Sent: 22/05/2018 8:03:20 PM
Subject: 77 Bower Street application Mod2018/0180

DW02.08	1200w x 2400	East	Corridor	Fixed clear glass window - doub
----------------	---------------------	-------------	-----------------	--

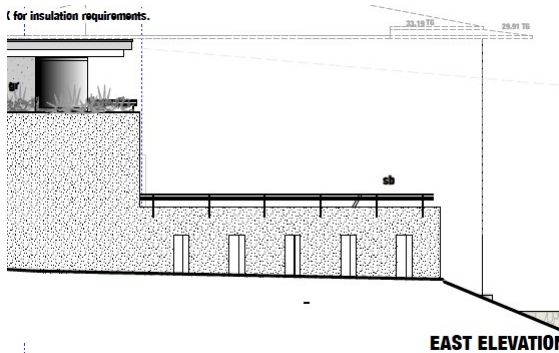
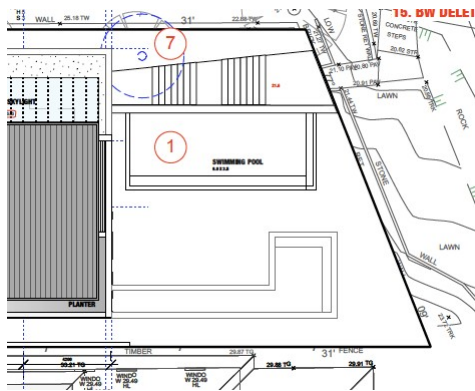
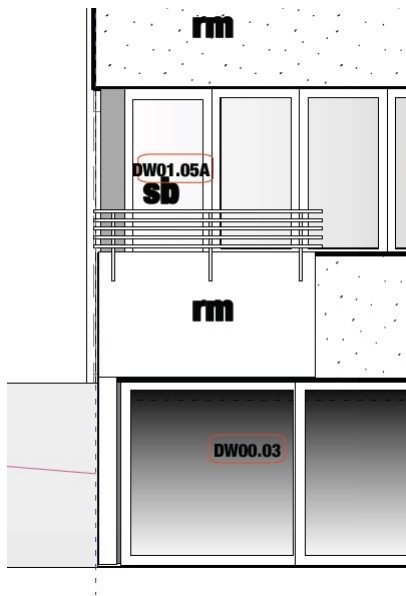
In addition ANS07 requires the window overlooking the pool area at 75 Bower St to be obscured glazing. The s.4.55 application marks it as clear glazing. This is a major deviation from the conditions of consent but it is written in microprint, not flagged in any way and not marked as a change.

ANS07

The window (DW02.08) to the hall/stair on Level 02 (DA06 - Eastern Elevation) is to be

obscured glazing. Details of compliance shall be submitted to the Council/Accredited Certifier, prior to the issue of any Construction Certificate. *Reason: To protect the privacy of the rear pool area of No.75 Bower St.*
